METROPOLITAN GOVERNMENT OF NASHVILLE AND DAVIDSON COUNTY

STAFF RECOMMENDATION
2813 Acklen Avenue
March 19, 2014

Application: New construction – addition and outbuilding; Setback determination
District: Hillsboro-West End Neighborhood Conservation Zoning Overlay
Council District: 18
Map and Parcel Number: 10411005000
Applicant: Torne White
Project Lead: Paul Hoffman, paul.hoffman@nashville.gov

Figure 1. Rear dormer and existing addition to be demolished

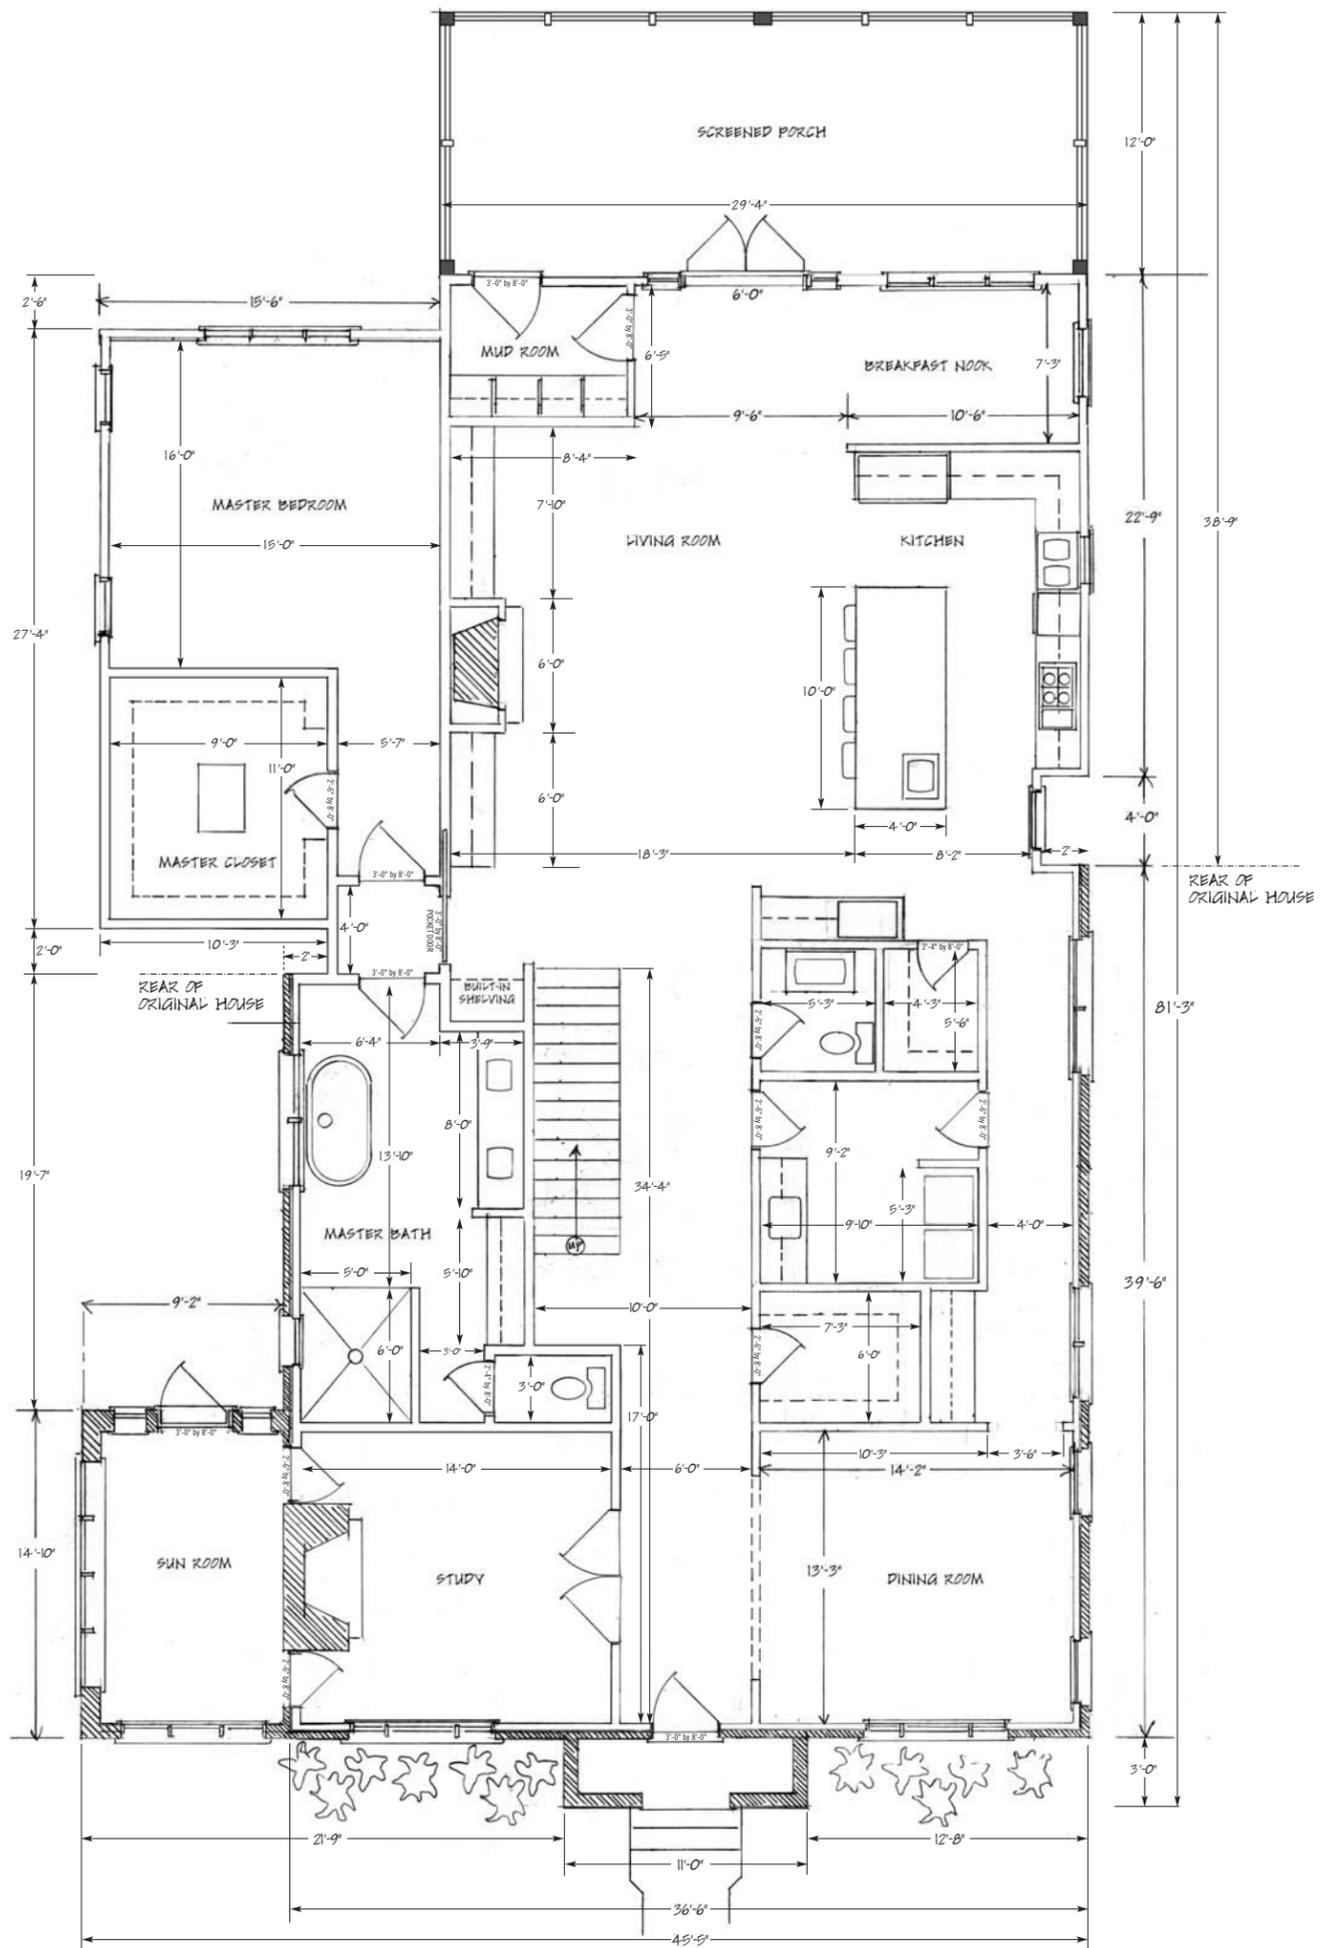
Demolition: The project calls for partial demolition of a rear shed dormer, a small rear addition and a carport. These are not character-defining features of the building, and their demolition will not detract from the historic character of the house and the district as a whole. The project meets section III.B.2 for appropriate demolition and does not meet section III.B.1 for inappropriate demolition.

FRONT ELEVATION
3/8" = 1 FOOT

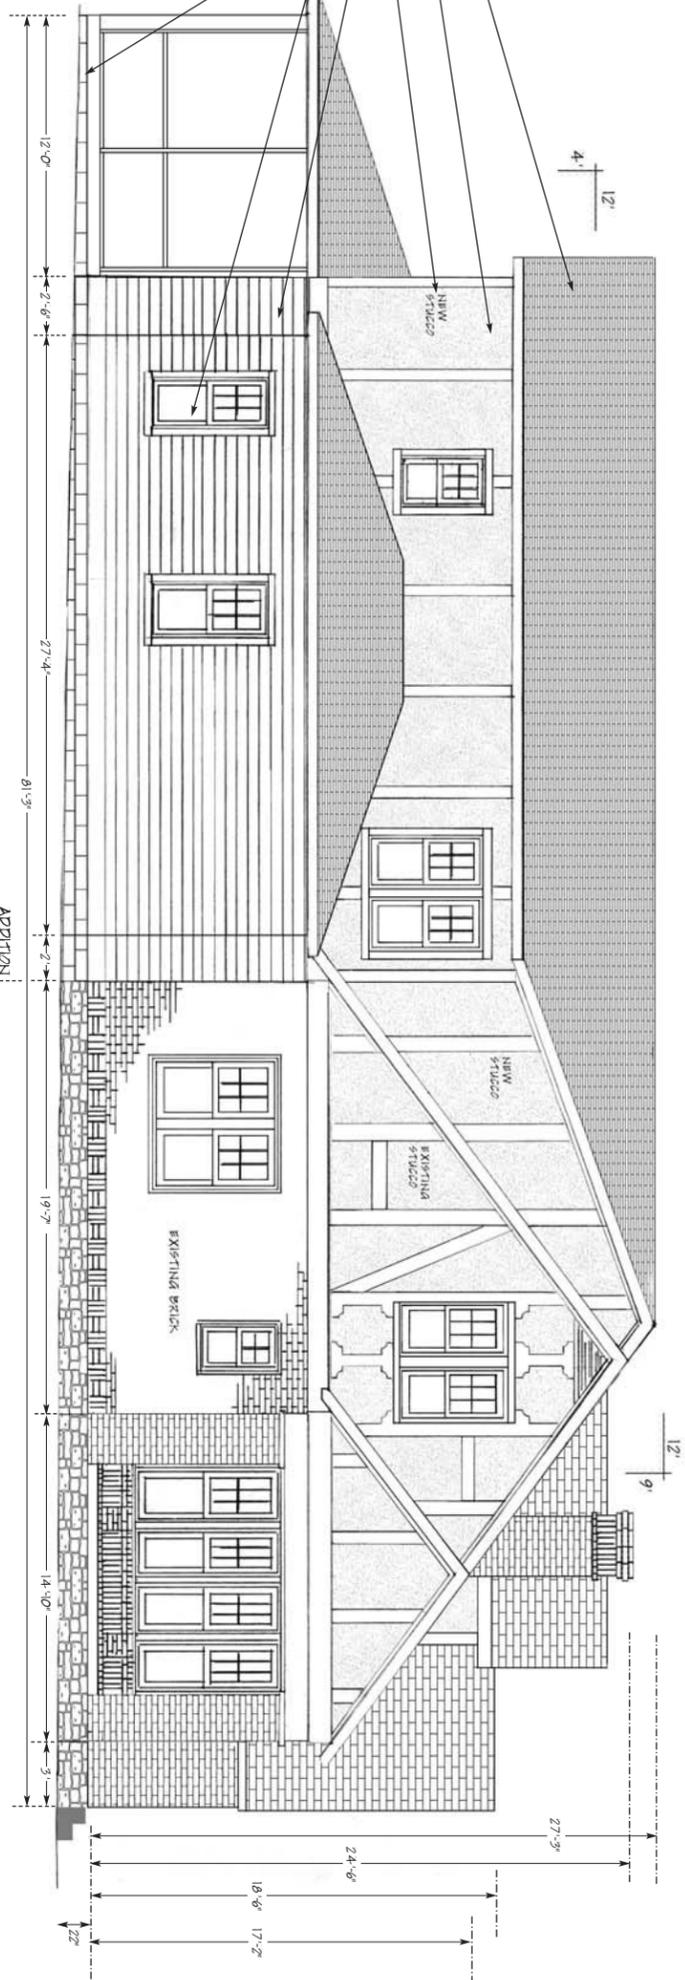
The applicant proposes a ridge raise to allow for conditioned space in the upper half-story. The raised portion sits in two feet (2') from each side wall and adds two feet (2') in the same plane as the existing roof slope. Staff finds the ridge raise meets design guidelines and is appropriate for this project as it doesn't require the removal of a chimney, ridge tiles or other character-defining features. Foundation height of twenty-two inches (22") will match the existing. The addition's eave height is seventeen feet two inches (17'2"). Staff finds the project meets section II.B.1.a. and b. and II.B.2.

Roof form: The existing house has a side-gabled roof form with a pitch of 9/12. The addition will have a gabled roof with 4/12 pitch. On the first story and covering the porch, the roof is hipped with a 4/12 pitch. Gabled and hipped roof forms are found in the Hillsboro-West End district and are appropriate for this project. The project meets section II.B.1.e. and II.B.2.

SIDE ELEVATIONS 1/4" = 1 FOOT

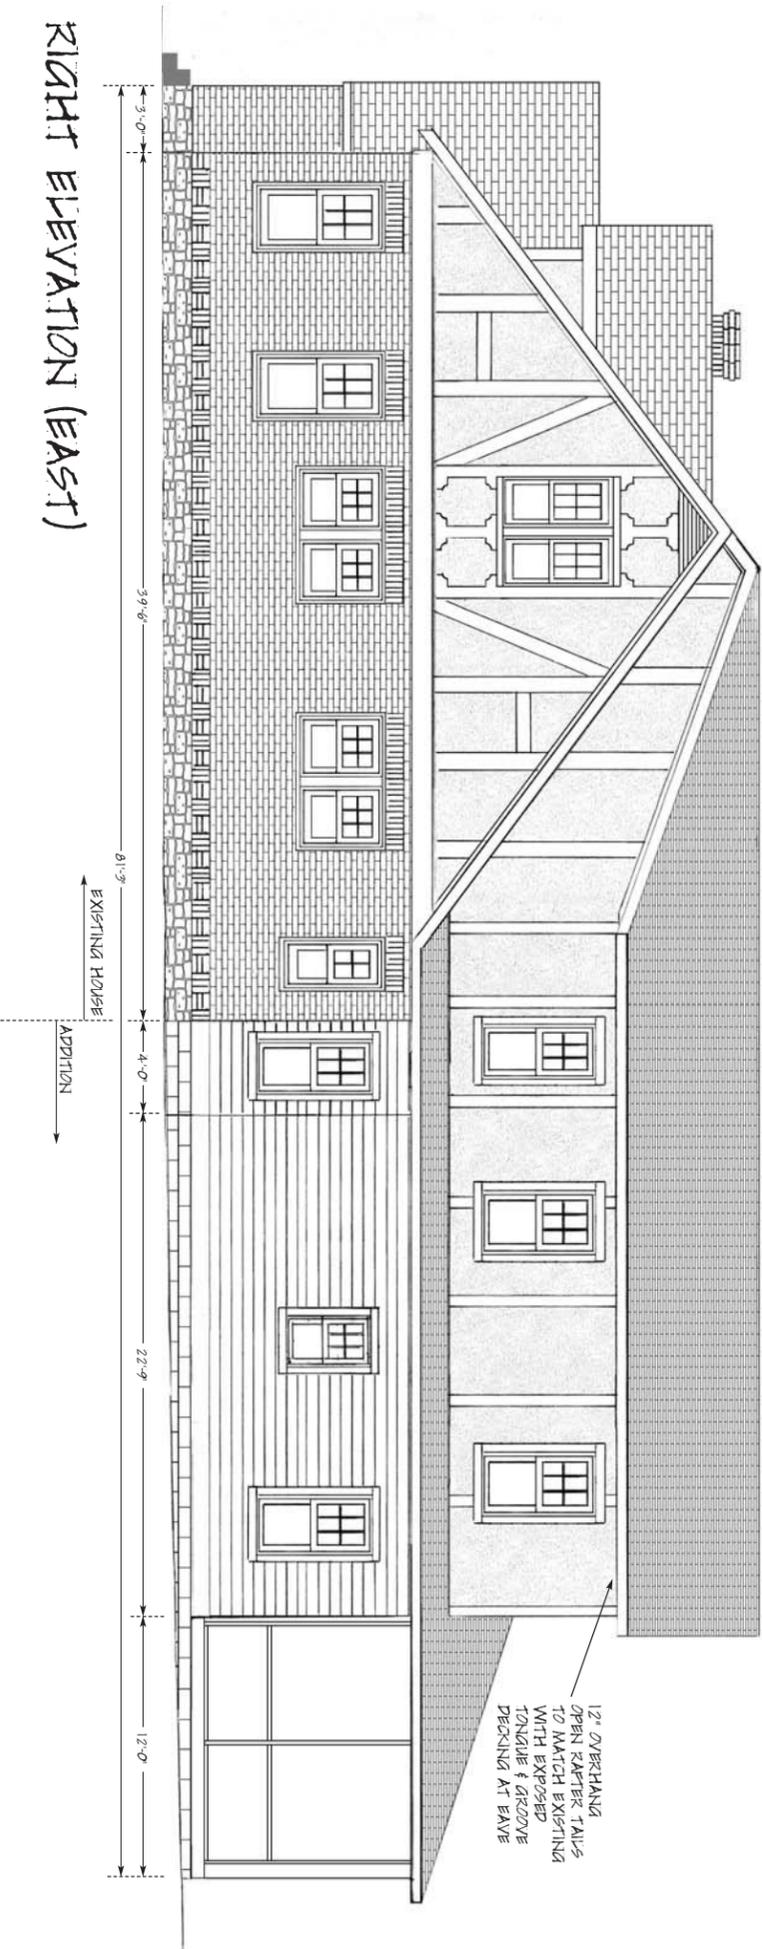
Materials: No major changes to the historic house's materials are indicated on the drawings. The addition will have smooth-face cement fiberboard on the first story with a five inch (5") reveal. The trim will be wood. The second story will be cement fiberboard panels with a stucco finish, matching existing stucco in the house's gable fields. The foundation will be split face concrete block. The roof will be architectural fiberglass shingles in a color to match the existing roof. Materials for the screened porch were not specified; staff requests to approve these materials. The windows and doors will be wood; staff requests to approve the final window and door selections prior to purchase and installation. The drawings indicate no changes to the driveway or walkways. With staff's final approval of the porch materials, windows and doors, staff finds that the known materials meet section II.B.1.d. and II.B.2.

Proportion and Rhythm of Openings: No changes to the window and door openings on the existing house were indicated on the plans. The windows on the proposed addition are all generally twice as tall as they are wide, thereby meeting the historic proportions of openings. There are no large expanses of wall space without a window or door opening. The longest expanse with no openings is approximately twelve feet (12') on the addition's left elevation. Staff finds the project's proportion and rhythm of openings to meet Section II.B.1.g. and II.B.2.

TWO CAR GARAGE 1/4" = 1 FOOT

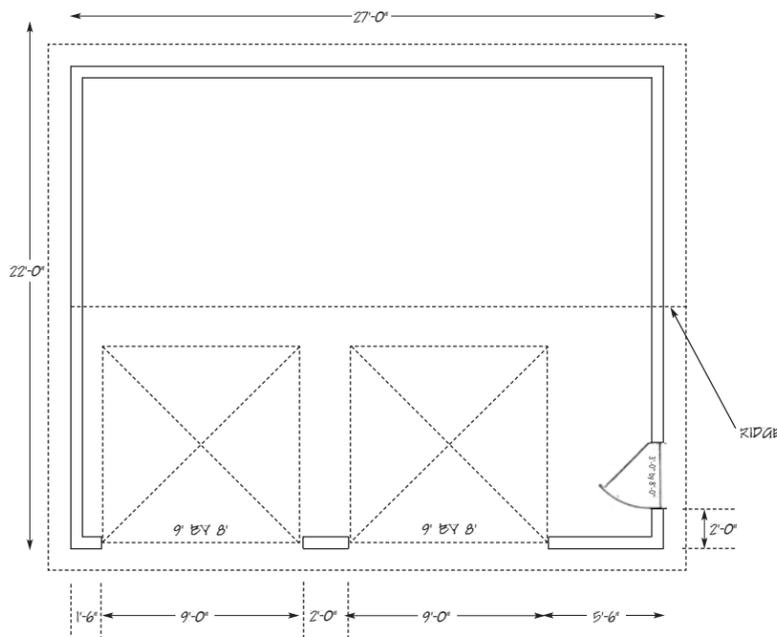
Outbuildings: The applicant proposes to build a one-story garage at the rear of the site. This outbuilding is twenty-seven feet (27') by twenty-two feet (22') for a total area of five hundred and ninety-four square feet (594 sq.ft.) It will have a ridge height of eighteen feet (18'). Eave height will be approximately ten feet (10'). The materials for the garage were not specified; staff requests final approval of materials. The outbuilding will be three feet (3') from the rear and side property lines, meeting setback requirements. With approval of materials for the garage, the project meets section II.B.1.h of the design guidelines.

- Staff have final approval of windows, doors, porch and garage materials; and,
- HVAC be located on the rear façade, or on a side façade beyond the midpoint of the house.

SITE PLAN 1/8" = 1 FOOT

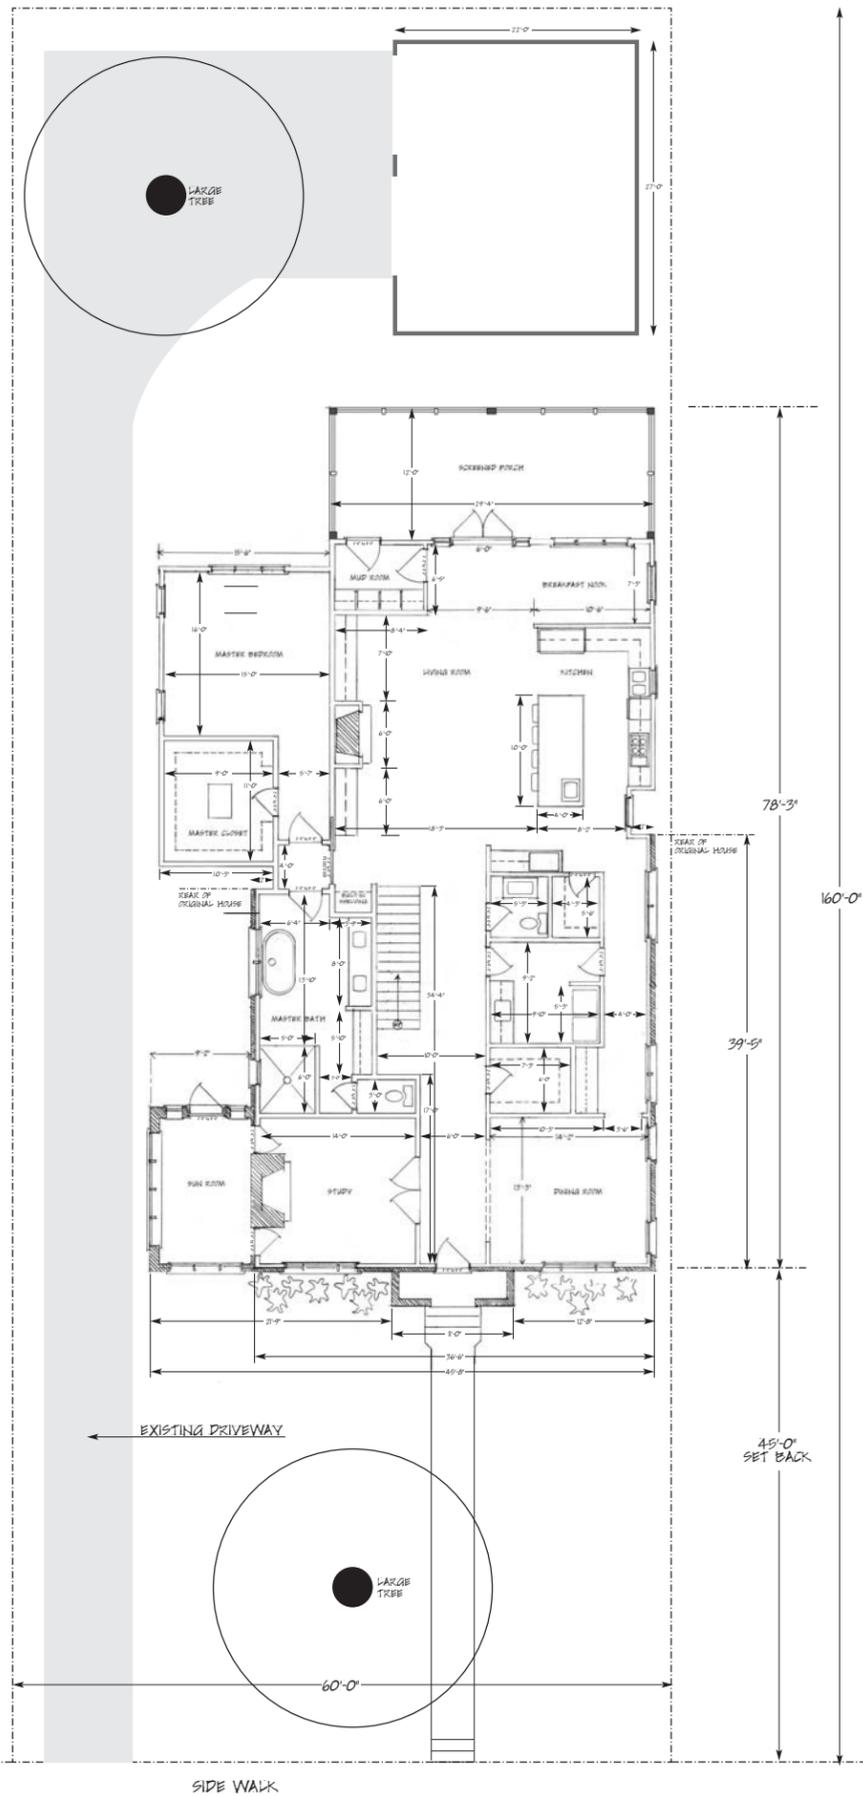
Setback & Rhythm of Spacing: The addition will be twenty-seven feet (27') from the rear property line, three feet (3') from the right side and eight feet (8') from the left. Although the addition is not wider than the house, a setback determination is requested from five feet (5') to three feet (3'). Staff finds this setback to be appropriate because the historic house does not currently meet the base zoning setback of five feet (5') and the addition is no wider than the historic house. The project meets section II.B.1.c. and II.B.2.

Appurtenances & Utilities: No changes to the site's appurtenances were indicated on the drawings. The location of the HVAC and other utilities was also not noted. Staff asks that the HVAC be located on the rear façade, or on a side façade beyond the midpoint of the house. The project meets section II.B.1. i.
